**WHEELING PLAN COMMISSION
THURSDAY, JANUARY 25, 2018 6:30 P.M.**

REQUEST FOR PLAN COMMISSION ACTION
STAFF PROJECT REVIEW

RE: **Docket No. SCBA 18-3**
Boston Fish Market
412 N. Milwaukee Avenue
Appearance Approval of Wall & Freestanding Signs

RE: Docket Nos. 2017-18 and SCBA 18-4
Shri Swaminarayan Temple
397 Northgate Parkway
(2017-18) Special Use-Site Plan Amendment to Allow for a
Building Addition
(SCBA 18-4) Appearance Approval of a Freestanding Sign

MONUMENT SIGN
LANDSCAPE PLAN

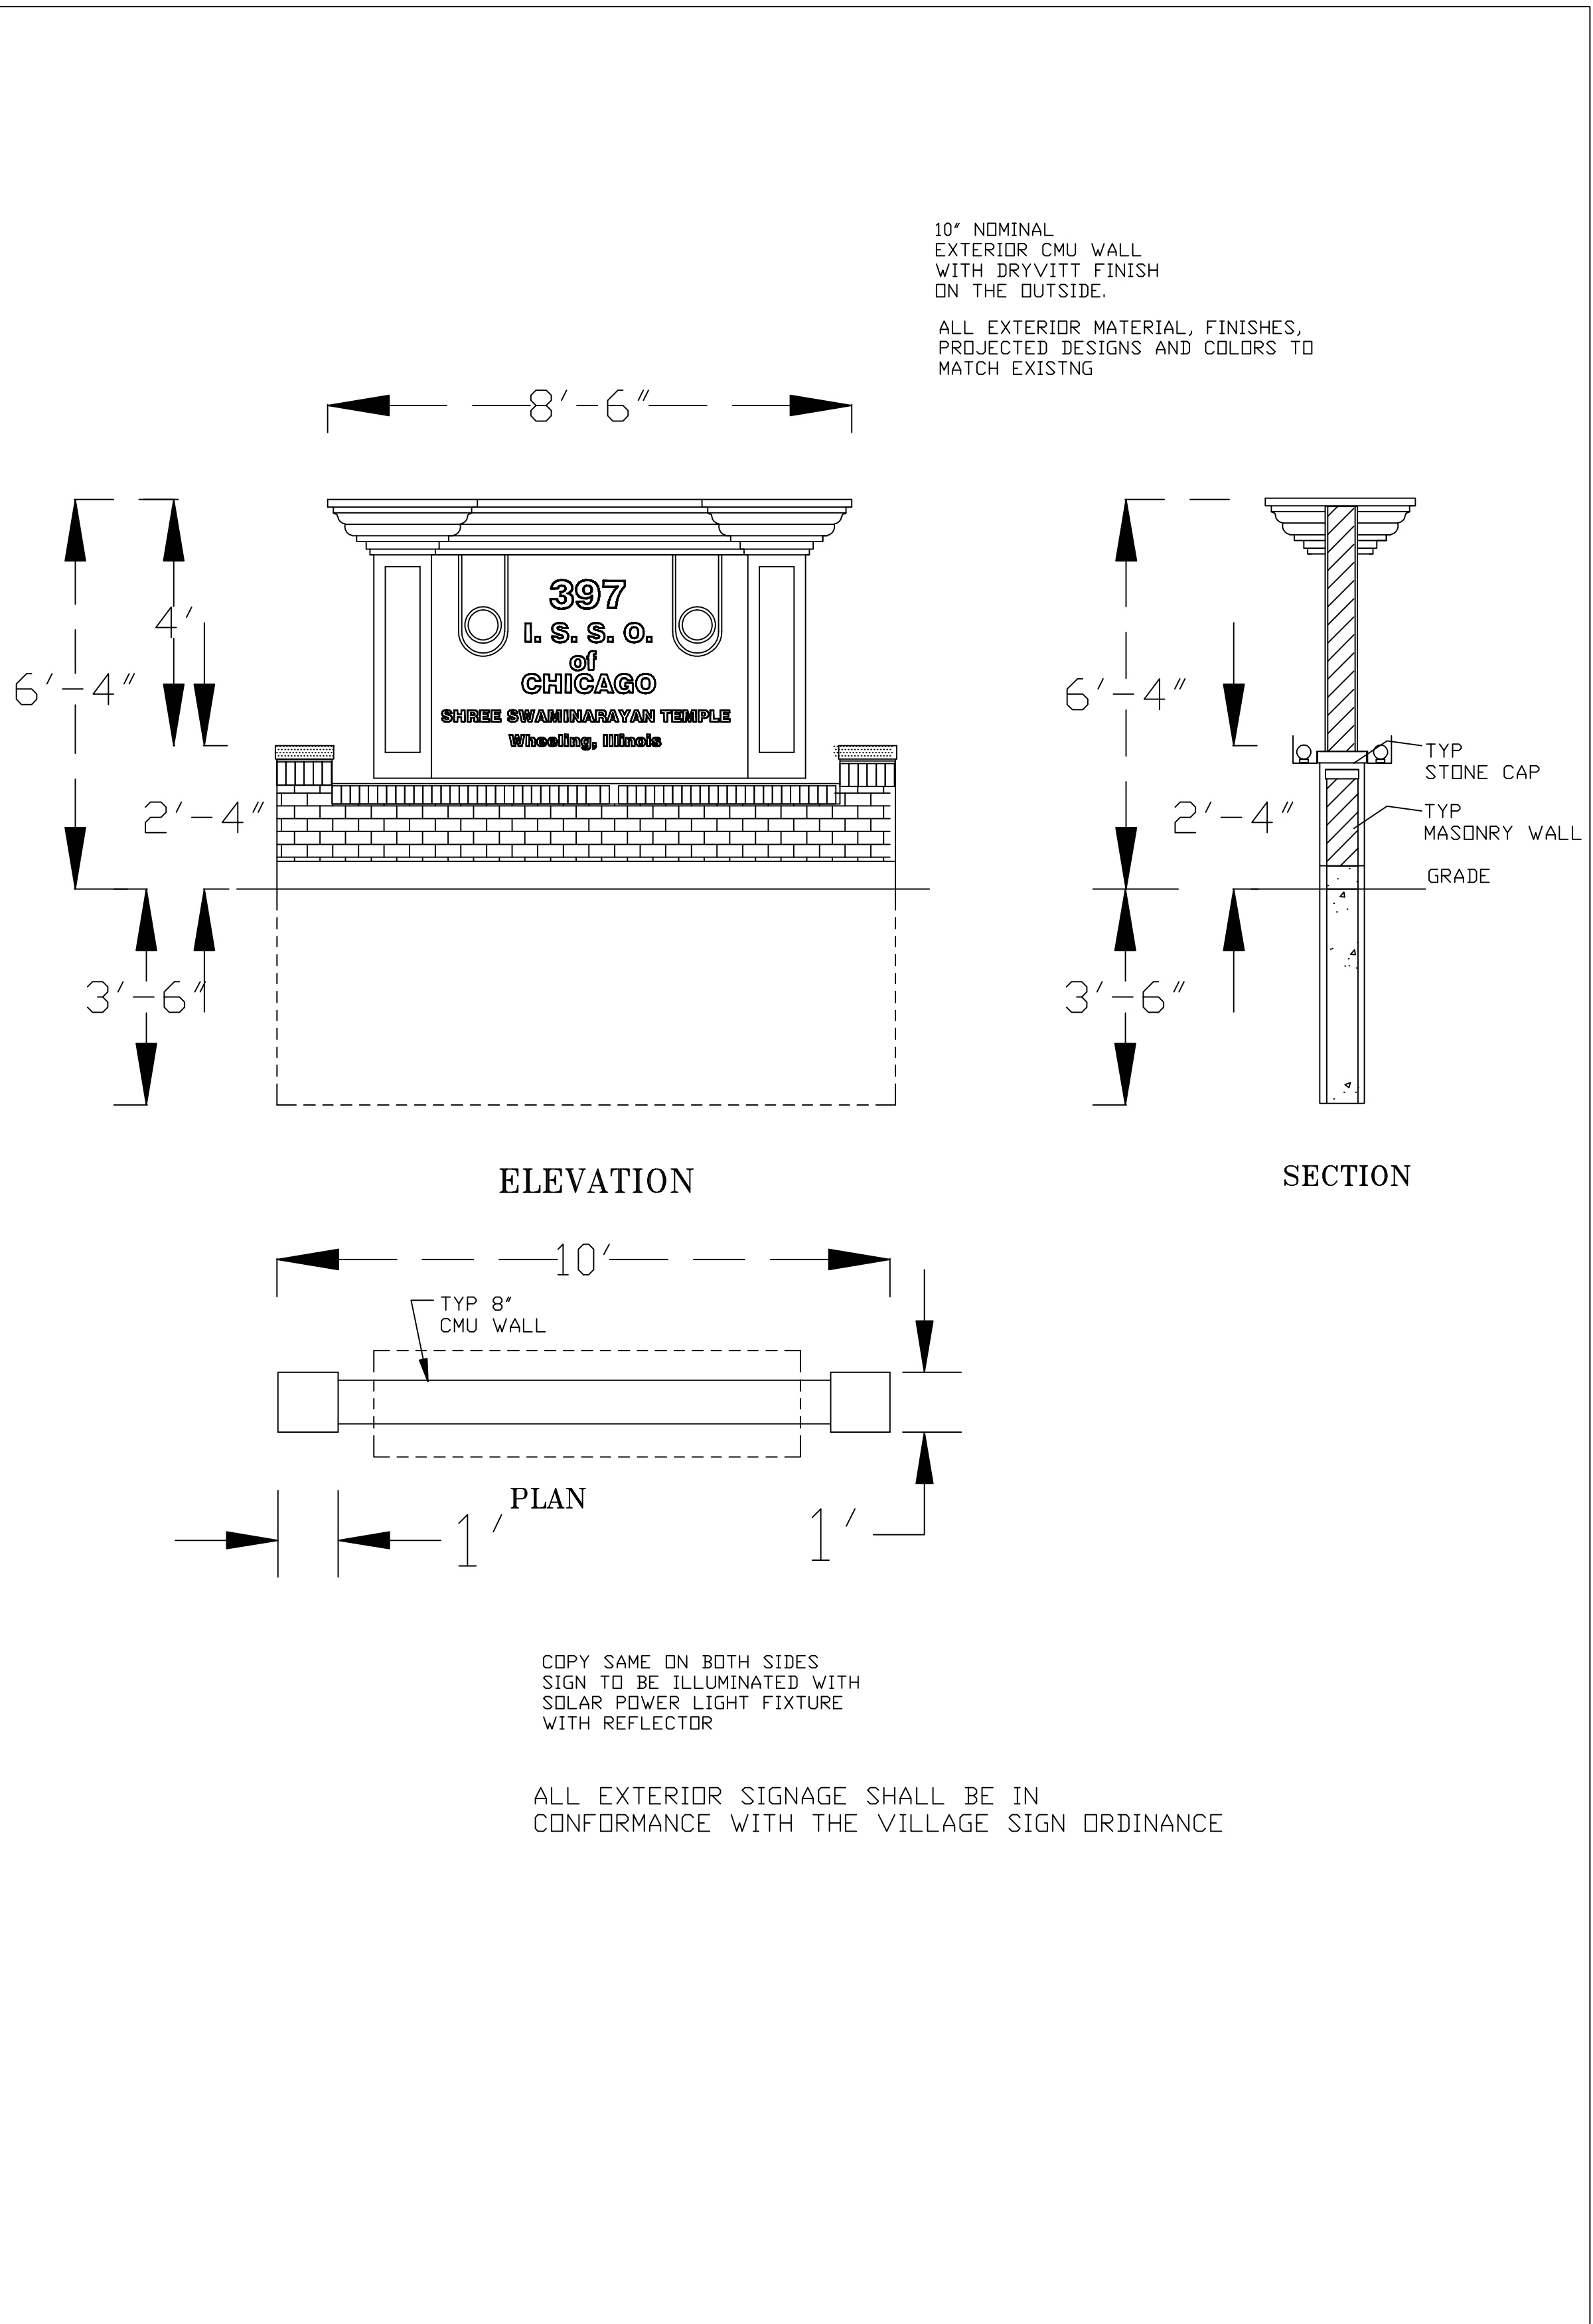
Landscaping: A landscape plan is proposed for the freestanding sign. The proposed landscaped area is approximately 240 square feet, which is over four times the size of the required landscaped area. The proposed landscape plan meets the species mix requirements of the Sign
